### **Product Change Notification**

#### PCN-IFC-9381-2024

Business Unit	Product Line Code	Type of Change	Action	Date of Issue
IFC - Industrial	BF7	Product Change	Notify Distributors and	1/19/2024
Field Connectivity		Notification	Field

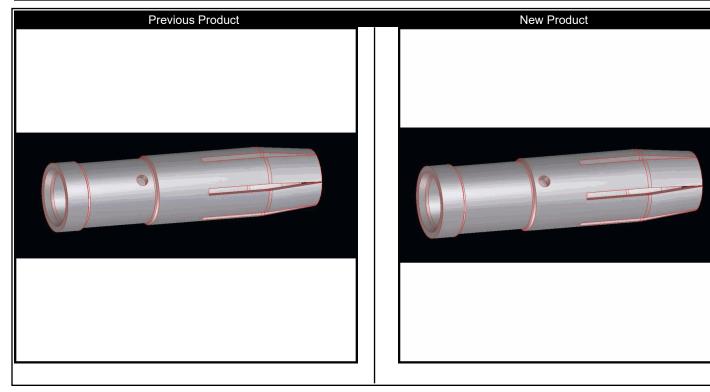
The inspection hole for the CK4,0 crimp contacts has been moved by approximately 2mm. It has moved from the crimping area toward the contact pin/socket mating area. This change better accommodates processing in automatic crimping devices.
